# 1990 Corvette: Service Bulletin: SIR Diagnostics and Procedures to Prevent Codes 16 and 26 Due to Corrosion Revised

**Subject:** SERVICE MAN. UPDATE SEC.9J A/B REV. SIR DIAGNOSTIC PROCEDURE

**Model and Year:** 1990 CORVETTE

**Bulletin Number:** 90-436-9J - (11/07/1991)

#### **FORWARD DISCRIMINATING SENSORS Figures 1 & 2 -----**

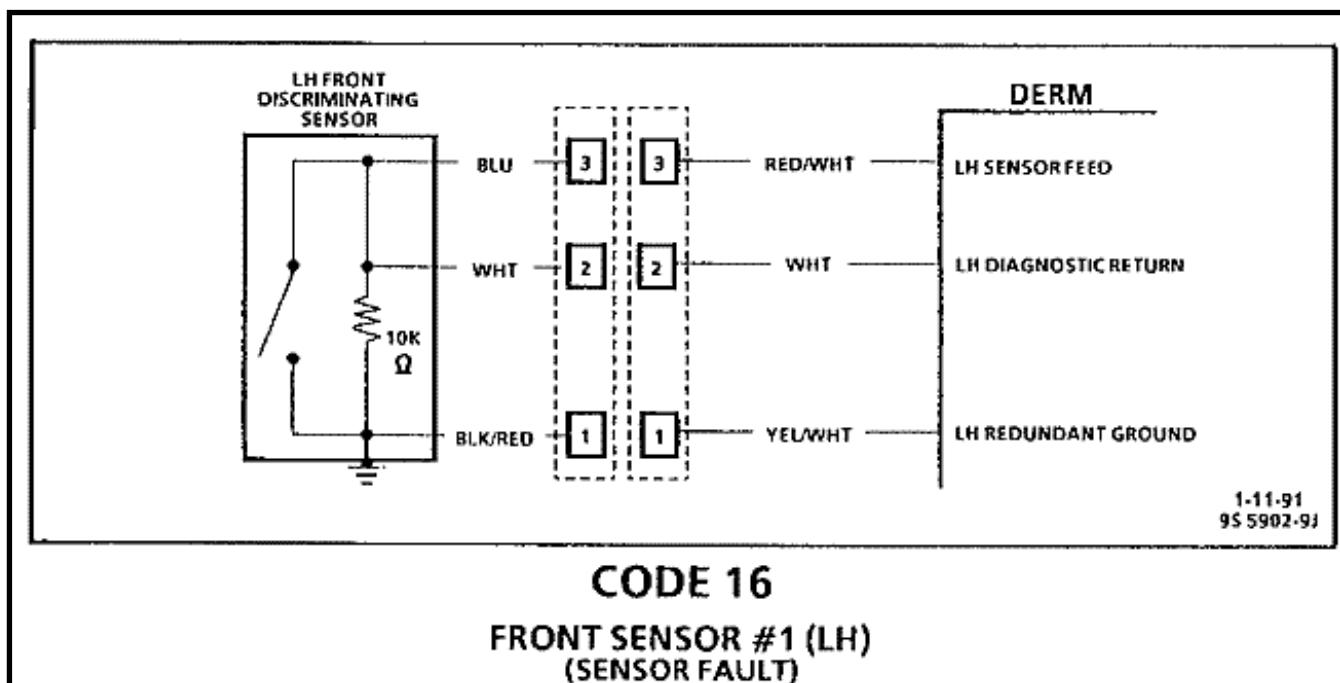
Caution should be used to assure proper location of sensors to the front frame rails. The keying of the sensors to the frame rails through the differently sized mounting bolt holes in the sensor mounting plate should never be modified in the field.

1. Apply a thin layer of special grease P/N 12345579 to the frame rail mounting surface and the mounting flange of the sensor. Do not apply the grease to the mounting bolts or holes.
2. Forward discriminating sensor, with arrow pointing toward front of vehicle.
3. External tooth lock washers, P/N 11501869 (8 mm) and 121753 (6 mm) to mounting bolts.
4. Sensor mounting bolts. Ensure that washers are between bolt head and sensor mounting flange, not between mounting flange and frame rail.

1. Apply a thin layer of special grease P/N 12345579 to the frame rail mounting surface and the mounting flange of the sensor. Do not apply the grease to the mounting bolts or holes.
2. Forward discriminating sensor, with arrow pointing toward front of vehicle.
3. External tooth lock washers, P/N 11501869 (8 mm) and 121753 (6 mm) to mounting bolts.
4. Sensor mounting bolts. Ensure that washers are between bolt head and sensor mounting flange, not between mounting flange and frame rail.

- Front (13 mm head) bolt to 25 N.m (19 lb. ft.) - Rear (10 mm head) bolt to 14 N.m (125 lb. ft.)

- Reservoir mounting screws to 10 N.m (89 lb. in.)

## CODE 16

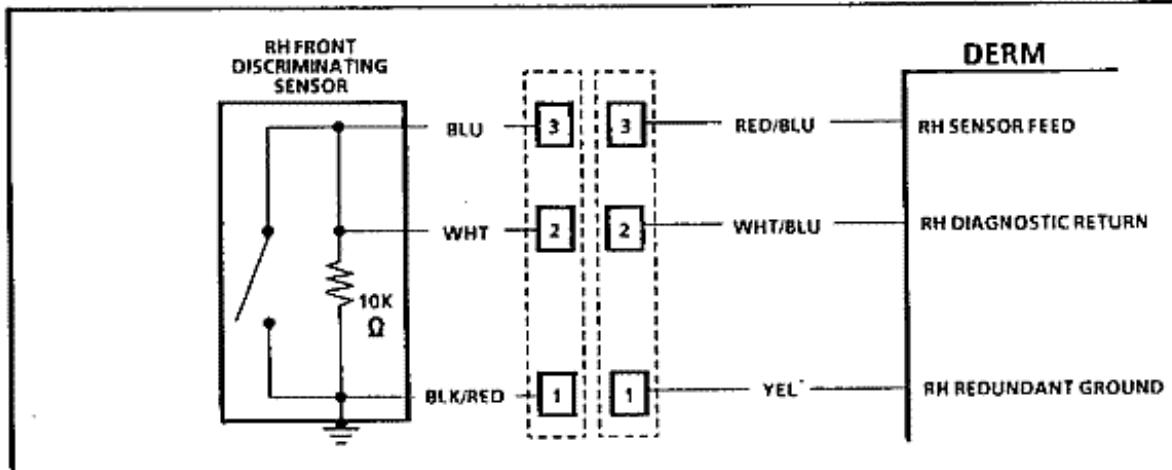
- IGNITION "OFF."
- DISCONNECT SENSOR CONNECTOR.
- USING ADAPTERS FROM J 37808-10 AND DVM J 34029-A OR DVM J 39200, MEASURE THE RESISTANCE BETWEEN TERMINALS IN THE SENSOR PIGTAIL CONNECTOR AS SHOWN BELOW. NOTE MEASUREMENTS FOR EACH CHECK.

SENSOR TERMINALS	RESISTANCE
1 AND 2	ABOUT 10,000 $\Omega$
1 AND 3	ABOUT 10,000 $\Omega$
2 AND 3	LESS THAN 1 $\Omega$

- REMOVE SENSOR; REFER TO "LEFT SENSOR" ON ATTACHED PAGES.
- CLEAN ANY PAINT AND/OR CORROSION FROM SENSOR AND FRAME RAIL MOUNTING POINTS AND MOUNTING BOLTS.
- INSTALL SENSOR; REFER TO "LEFT SENSOR" ON ATTACHED PAGES TO APPLY SPECIAL GREASE AND LOCK WASHERS UPON INSTALLATION TO HELP PREVENT RECURRANCE OF CODE 16 DUE TO CORROSION.
- CLEAR CODES (TECH 1 PREFERRED).
- IGNITION "OFF," THEN "ON."
- DOES CODE 16 RESET?

- REMOVE SENSOR; REFER TO "LEFT SENSOR" ON ATTACHED PAGES.
- CLEAN ANY PAINT AND/OR CORROSION FROM FRAME RAIL MOUNTING POINTS AND MOUNTING BOLTS.
- INSTALL NEW SENSOR; REFER TO "LEFT SENSOR" ON ATTACHED PAGES TO APPLY SPECIAL GREASE AND LOCK WASHERS ON INSTALLATION TO HELP PREVENT RECURRANCE OF CODE 16 DUE TO CORROSION.
- CLEAR CODES (TECH 1 PREFERRED).
- IGNITION "OFF," THEN "ON."
- DOES CODE 16 RESET?
